CITY OF PORTLAND, OREGON – BUREAU OF DEVELOPMENT SERVICES

LFS 12-10  
Technical revision

SUBJECT: **Site Evaluation Report** Land Feasibility Study Application # 10-126392-SE  
For Property: 13610 NW SKYLINE BLVD/SECTION 25 2N 2W 2N2W25; TL 3500 34.17 ACRES;

SUBJECT: **Site Evaluation Report** Land Feasibility Study Application # 10-126392-SE  
For Property: 13610 NW SKYLINE BLVD/SECTION 25 2N 2W 2N2W25; TL 3500 34.17 ACRES;

LFS 12-10

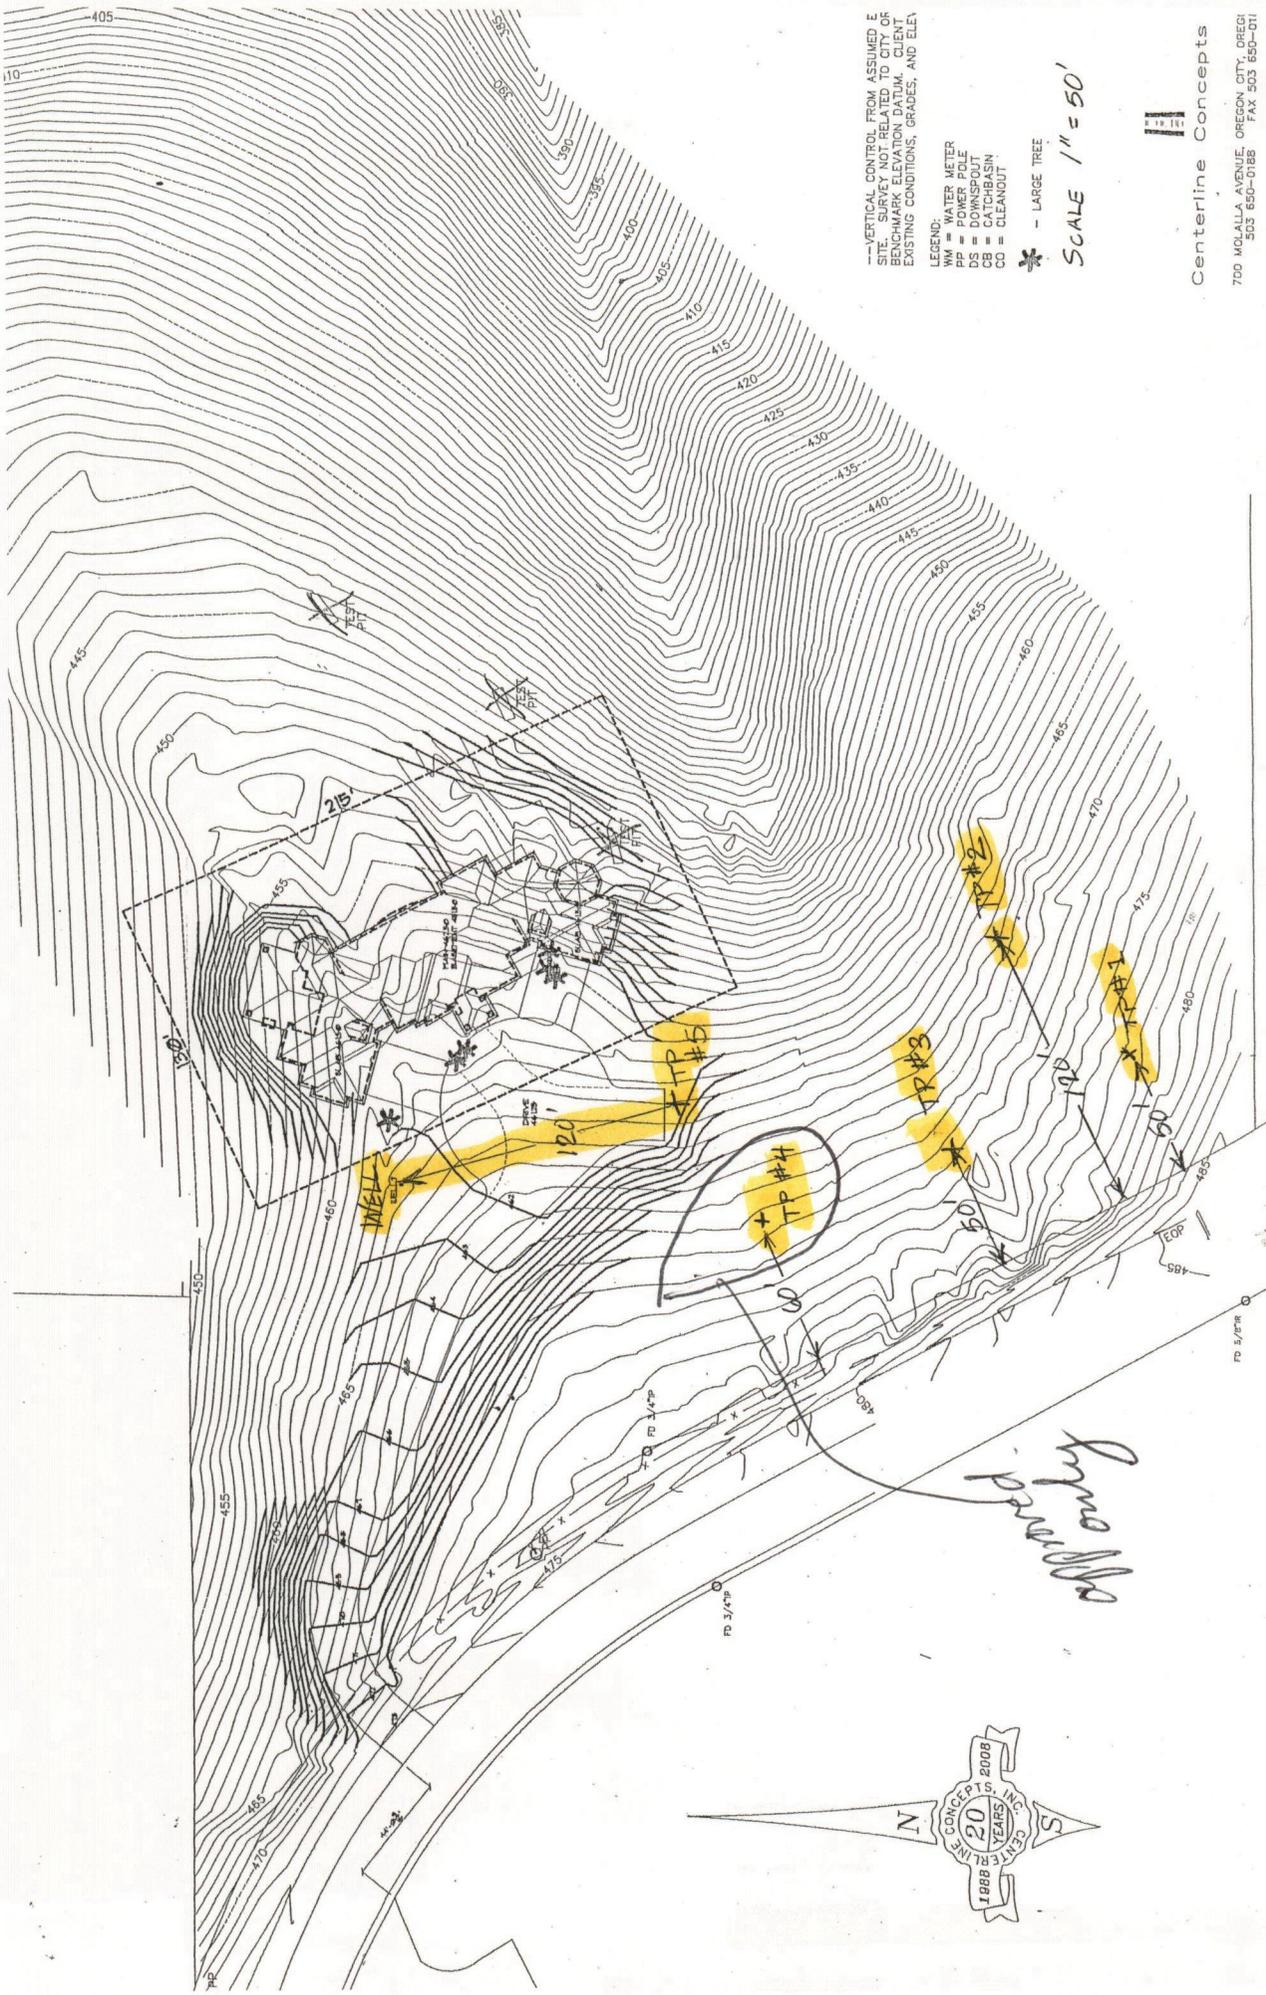
T.P. #5  $H_2O$  in Pit

T.P. #4  $H_2O$  in Pit

T.P. #3  $H_2O$  in Pit / near surface  
downslope (E side)

T.P. #2  $H_2O$  9" from surface.

T.P. #1  $H_2O$  in pit

New LFS (make sure  
new SE  
w/ 850 lbs)  
(they didn't.)

1000 gal septic and 500 gal diox  
tank.

Equal w/ 1/2 pipe ~~dist~~

382F per bdm  $\Rightarrow$  150 2F for 1<sup>st</sup> 4,  
25 4F ca.  $\Rightarrow$  4.

12" max ~~thin~~ around T.P. #4  
only.

6 WI @ 48" deep above ~~T.P. #4~~  
proposed D.F.

1. One, 1000 gallon septic tank and 500 gallon dose tank.
2. Equal distribution system with 1/2 pipe.
3. 38 lineal feet of absorption trench per bedroom for a total of 150 LF for the first four bedrooms and 25 LF for any bedrooms over four. Note: The system needs to be sized for a minimum of four bedrooms.
4. 12" max and min trench depth around TP #4 only.
5. GWI at 48" deep, 10' upslope of proposed drainfield.
